**ADDENDUM 1**

**CITY OF AMES**

**PROJECT:** Freel Drive Paving

**ADDENDUM NUMBER:** 1

NOTE: THE SIDEWALK FROM STA 0+37.04 - STA 13+50 IS INCLUDED IN ADD ALTERNATE 2.

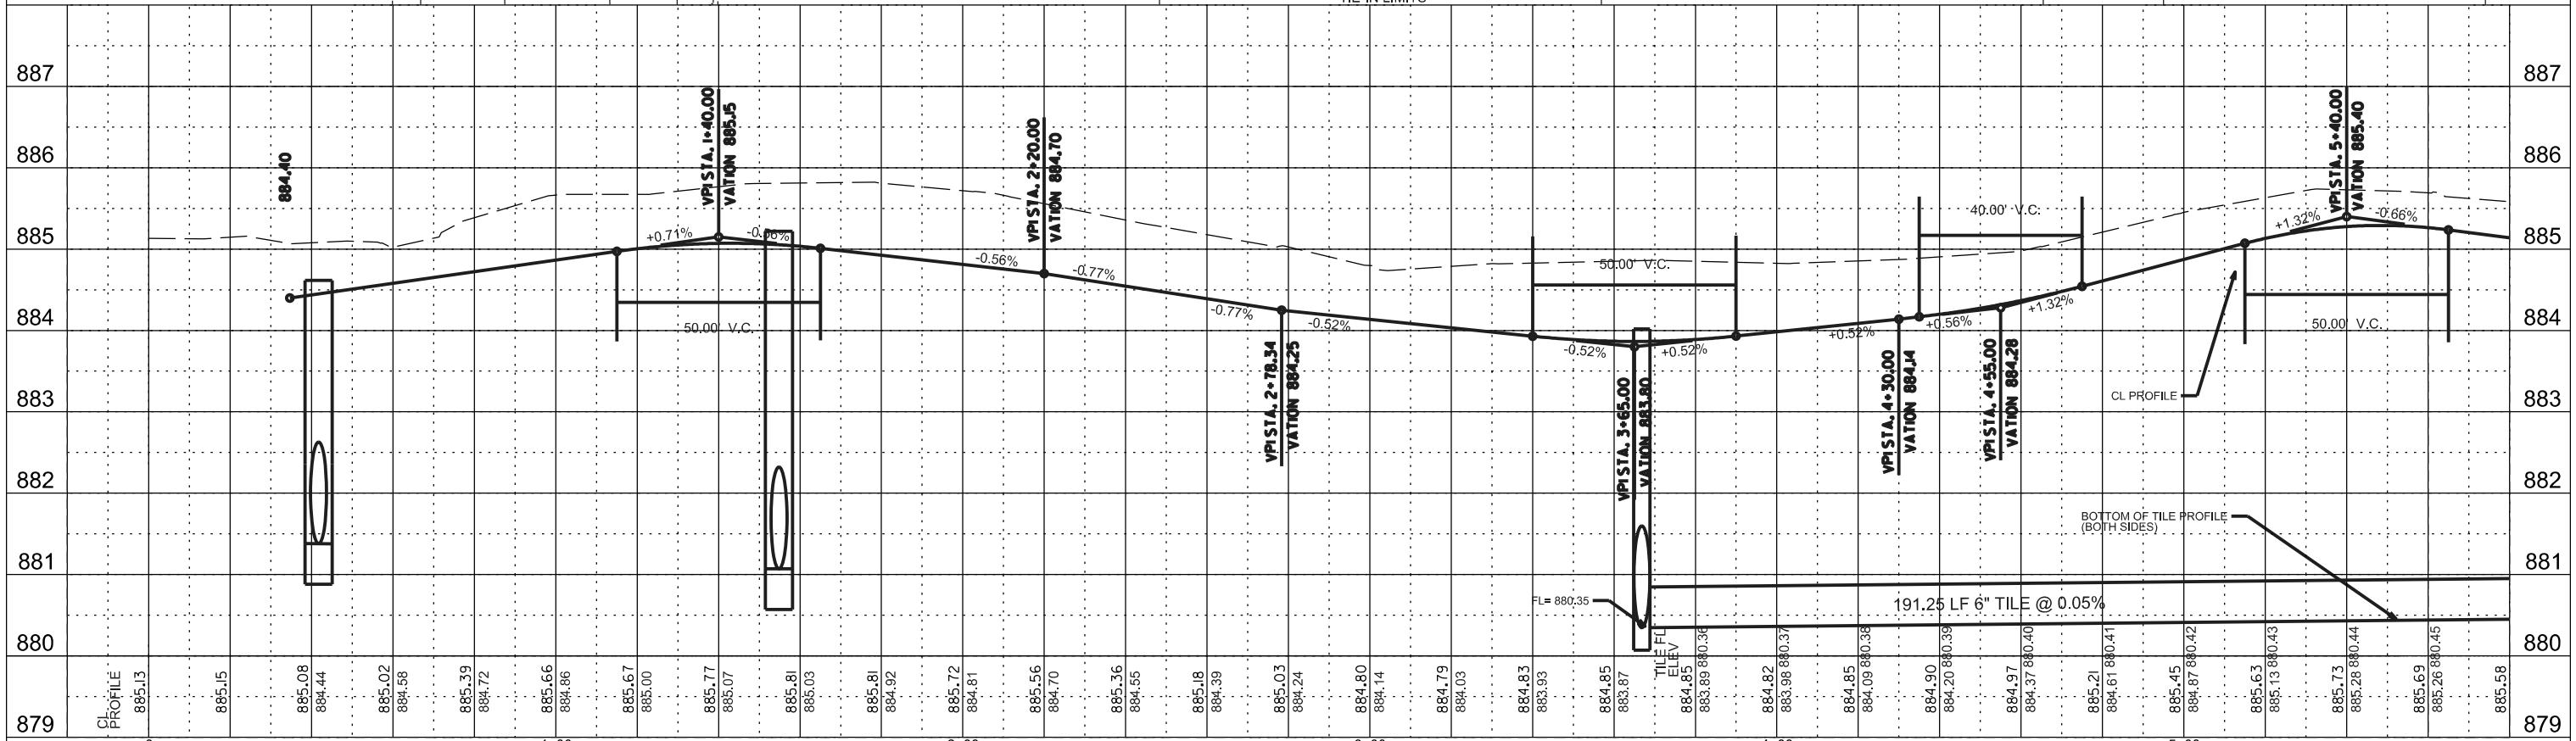
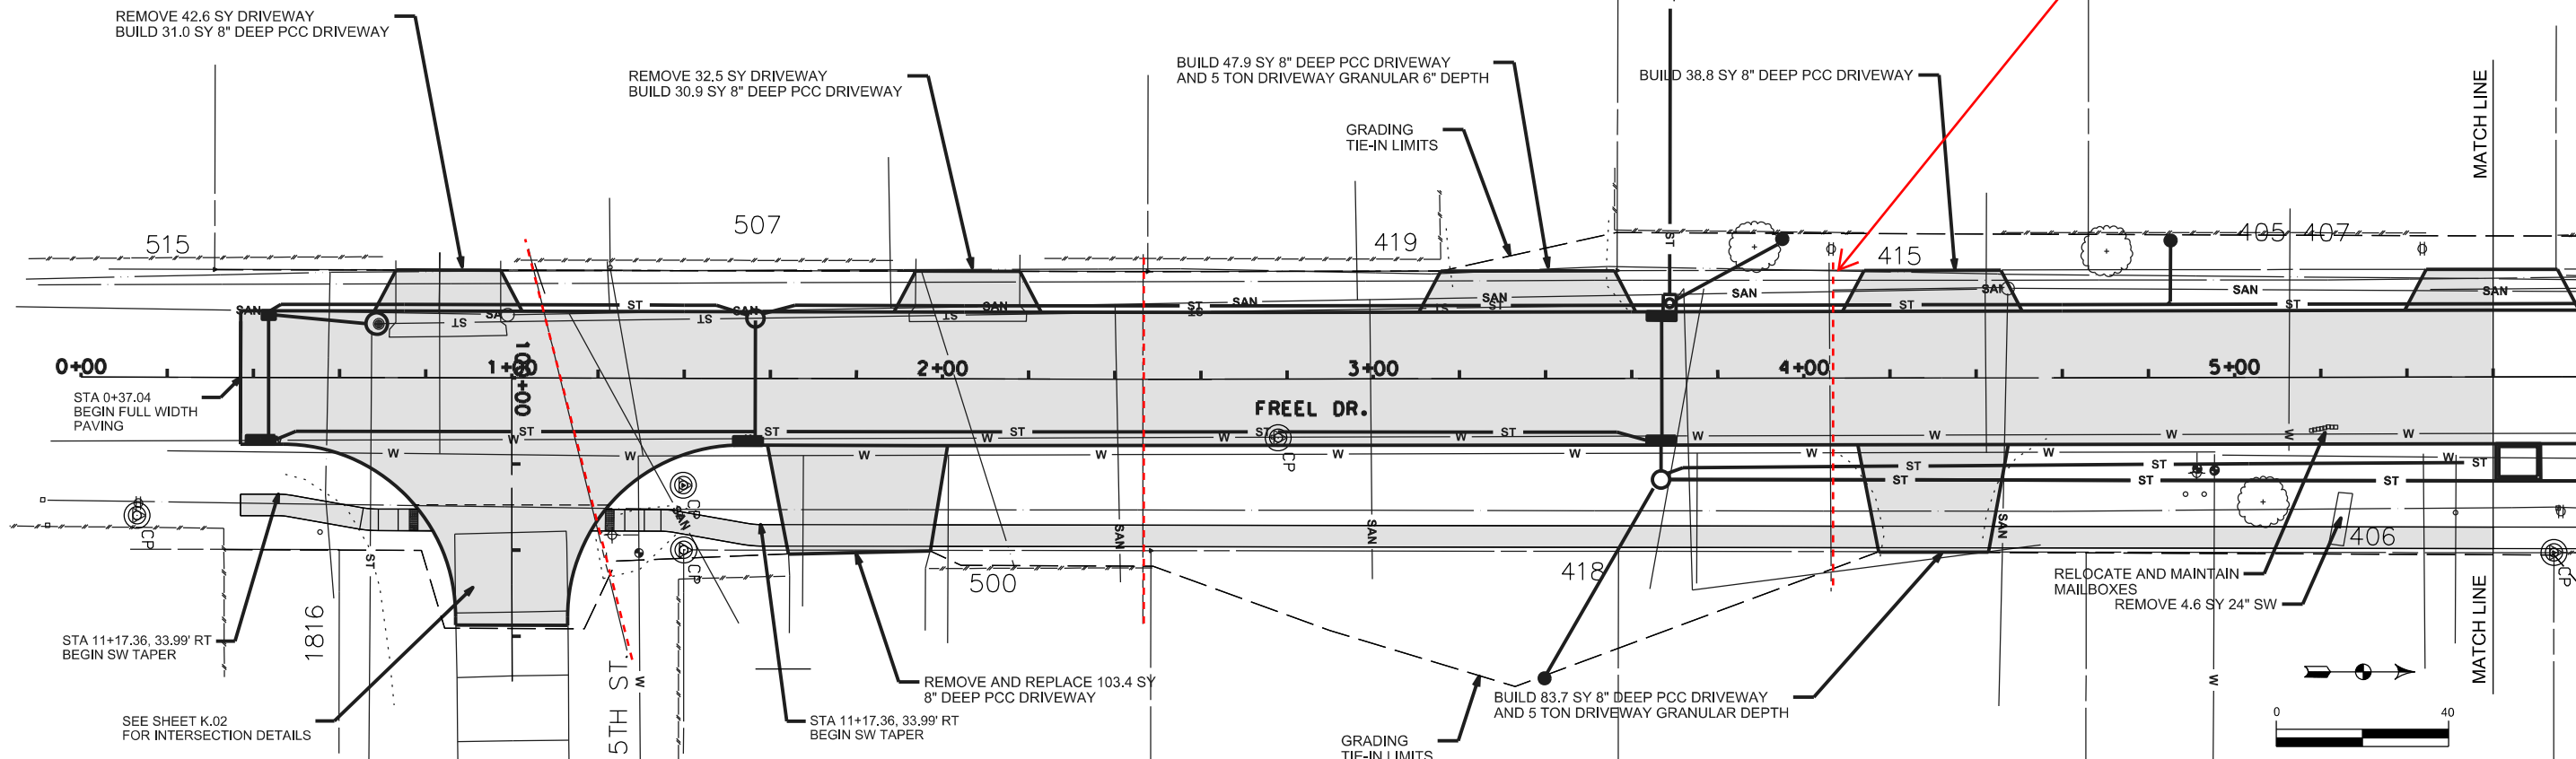
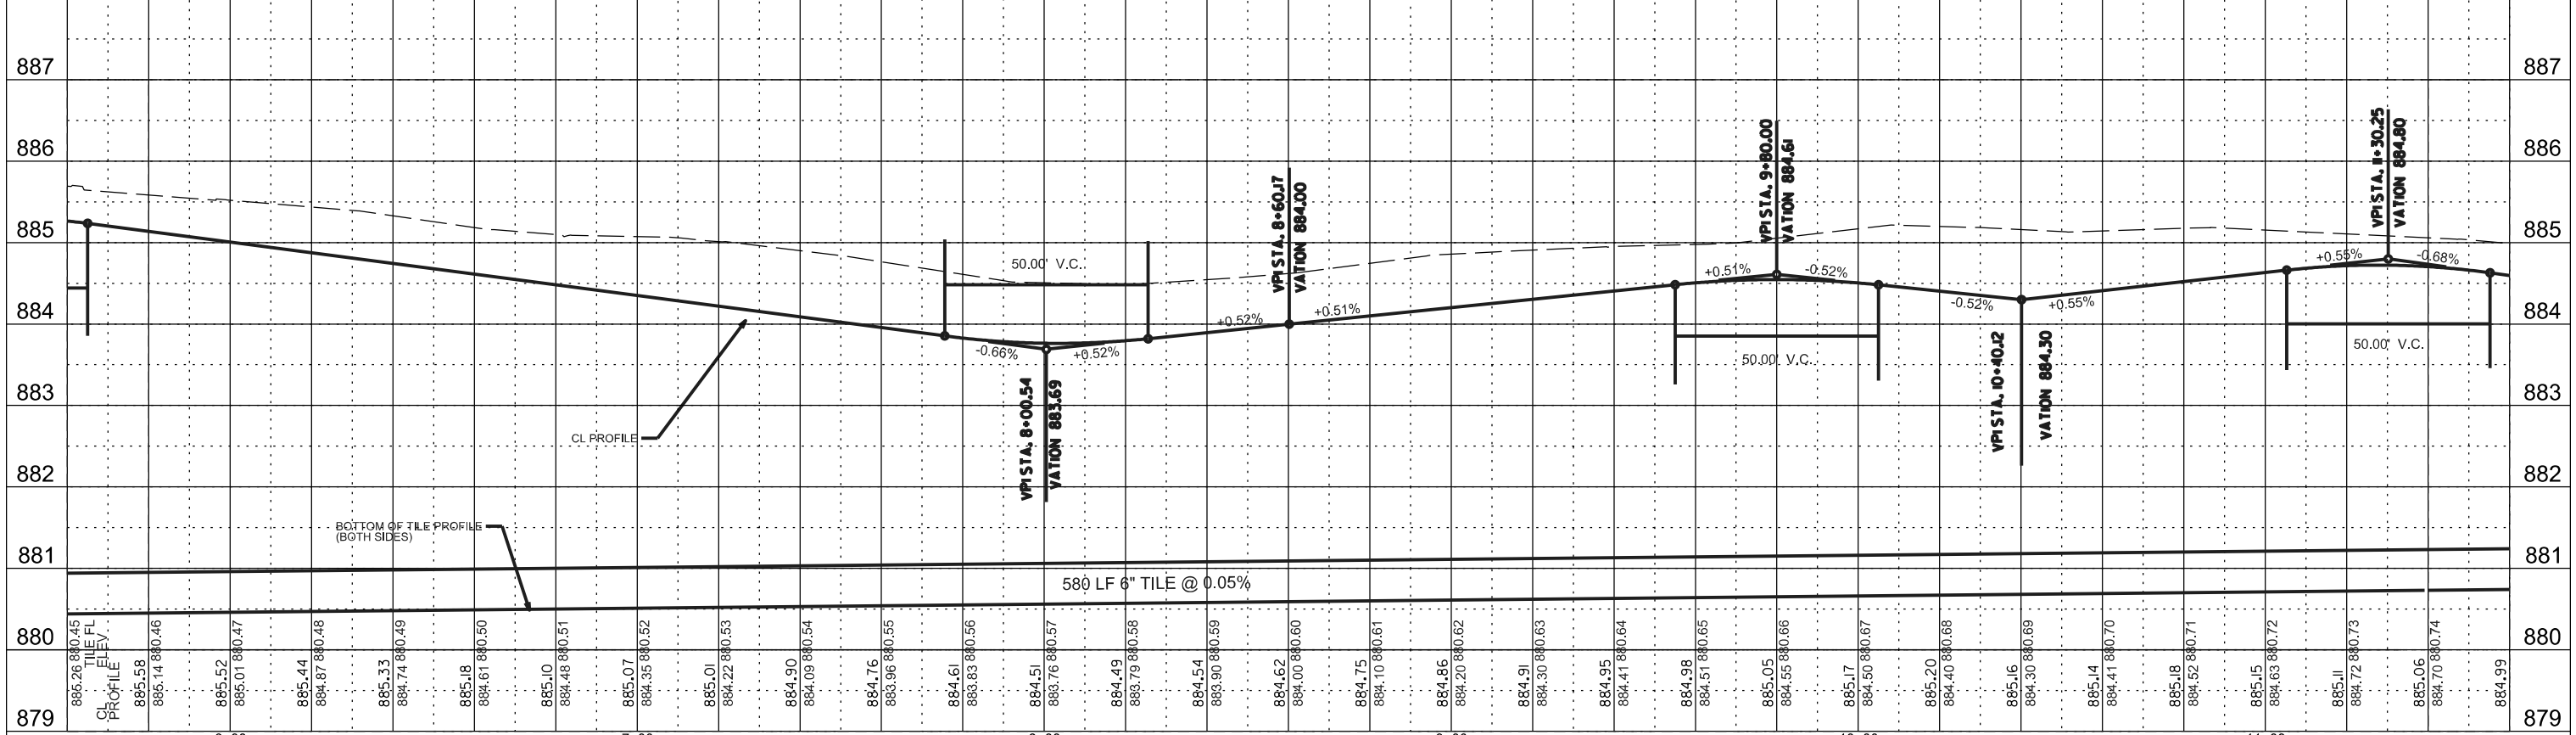
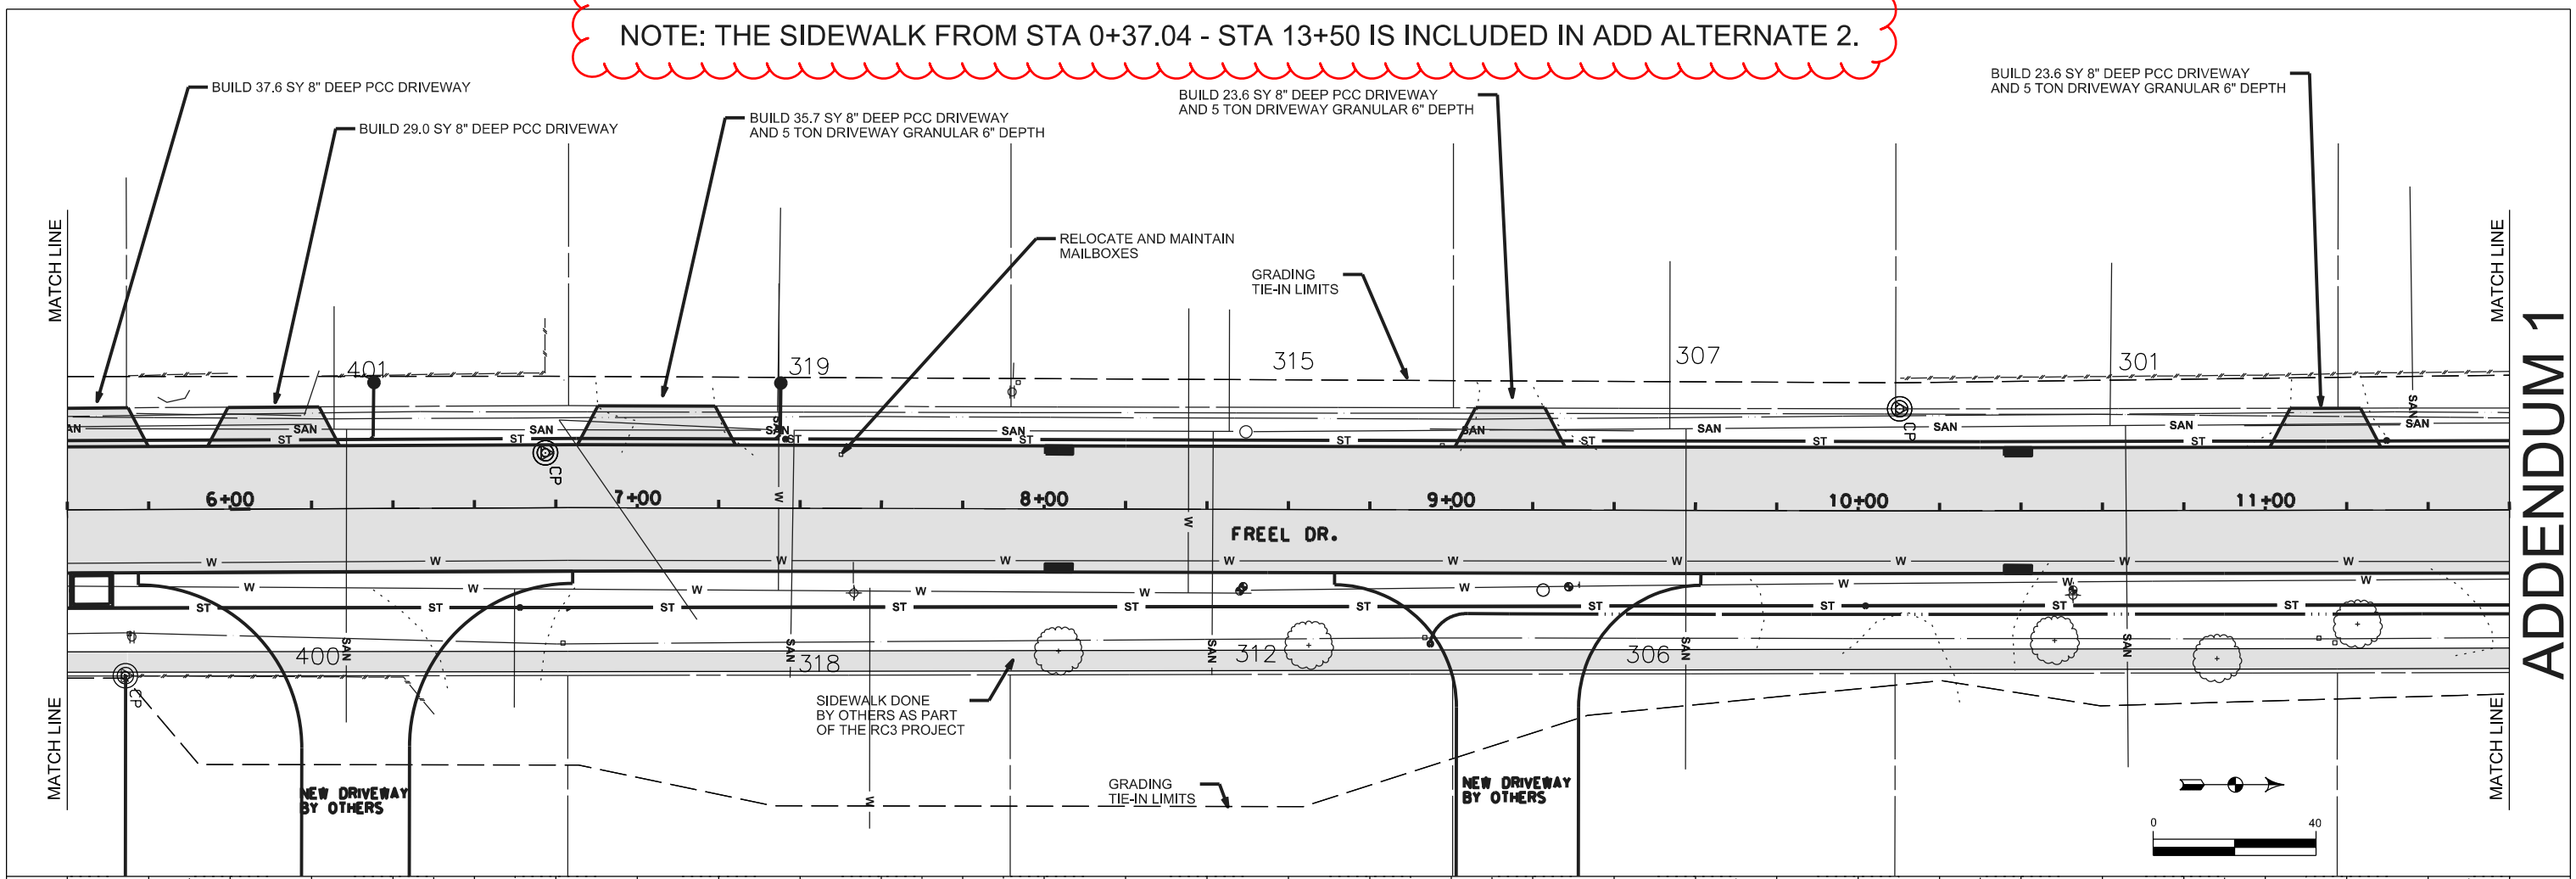
Sidewalk from STA 37+04 to STA 13+50 is now included in Alternate 2
